WIND DANCE ESTATES SUBDIVISION,
FIRST AND SECOND ADDITIONS,
RESUBDIVISION OF LOT 4A

APPLICATION NUMBER 7 DATE May 18, 2017
APPLICANT Wind Dance Estates Subdivision, First and Second Addition, Resubdivision of Lot 4A
REQUEST Subdivision

WIND DANCE ESTATES SUBDIVISION, FIRST AND SECOND ADDITIONS, RESUBDIVISION OF LOT 4A

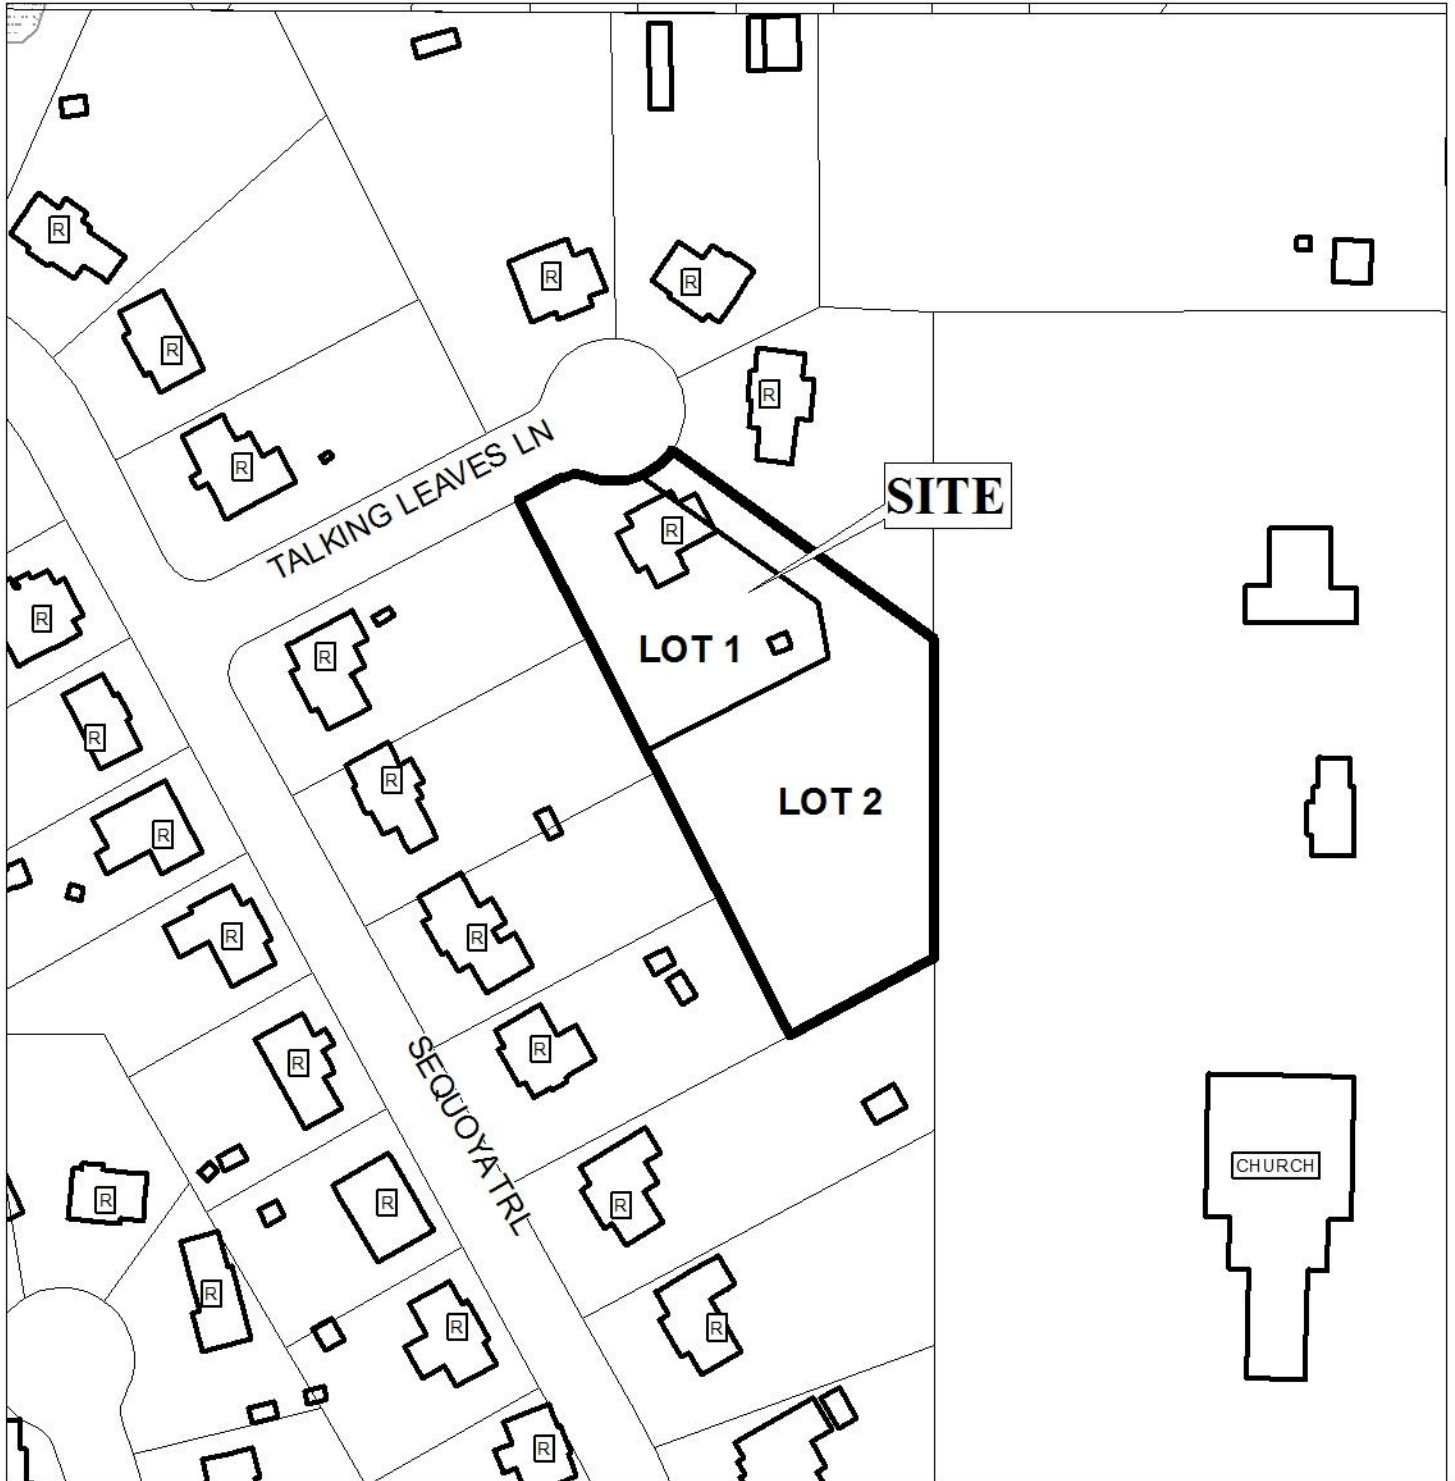
The proposed lots front Talking Leaves Lane. Talking Leaves Lane is a paved minor street with ribbon curb and gutter. As a paved minor street with ribbon curb and gutter, this street requires a 50' wide right-of-way width. The existing right-of-way width is depicted as 50' on the preliminary plat, and should be retained as such on the Final Plat, if approved.

The suggested site configurations for the proposed Lots 1 and 2 create irregular-shaped lots. Specifically, the proposed configuration for Lot 2 creates a flag lot. According to Section V.D.1. of the Subdivision Regulations, panhandle or flag lots are generally not allowed, but may be permitted in those locations where varied and irregularly-shaped lot designs are common and the informality of design is consistent with other lots in the vicinity; where unusual circumstances such as an odd shaped lot exists; separate disparate uses that exist on a single lot; where there are natural or pre-existing man-made barriers which may cause an undue hardship on the land owner; or in the case of a family division. It appears that there are flag lots located within close proximity to the subject site; however, there are no flag lots located within the immediate vicinity of the subject site in the Wind Dance Estates First and Second Additions Subdivision. It should be noted that there is only one building structure located on the existing site, and the applicant did not provide any details regarding the need for the two-lot subdivision and the irregular-shaped flag lot configuration for the proposed Lot 2.

The 25-foot minimum building setback line is not depicted on the preliminary plat along Talking Leaves Lane for the proposed lots. If approved, the 25' minimum building setback line should be depicted on the Final Plat for both Lots 1 and 2 where they are least 60' wide.

The lot size information is depicted in both square feet and in acres on the preliminary plat; however, the applicant did not provide any information on the provider for water service to the subject site. This information is pertinent in determining if the suggested lot size for each proposed lot is sufficient and compliant with the Subdivision Regulations: either a 15,000 square foot or 40,000 square foot minimum lot size will be required. The service provider for both water and sewer should be revised on the application and/or provided in a written statement on the Final Plat, if approved.

As a means of access management, a note should be placed on the Final Plat, if approved, stating that Lot 1 is limited to the existing curb cut to Talking Leaves Lane and Lot 2 is limited to one curb cut Talking Leaves Lane, with any changes to the size, design and location of the curb-cuts to be approved by Mobile County Engineering and conform to AASHTO standards.

Based on the preceding, this application is recommended for Denial, due the following reasons:

- 1) the proposed subdivision would result in a lot that does not meet the shape requirements of Section V.D.1 of the Subdivision Regulations; and,
- 2) insufficient information was provided to determine if the proposed subdivision would comply with the minimum dimensions as set forth in Section V.D.2. of the Subdivision Regulations.
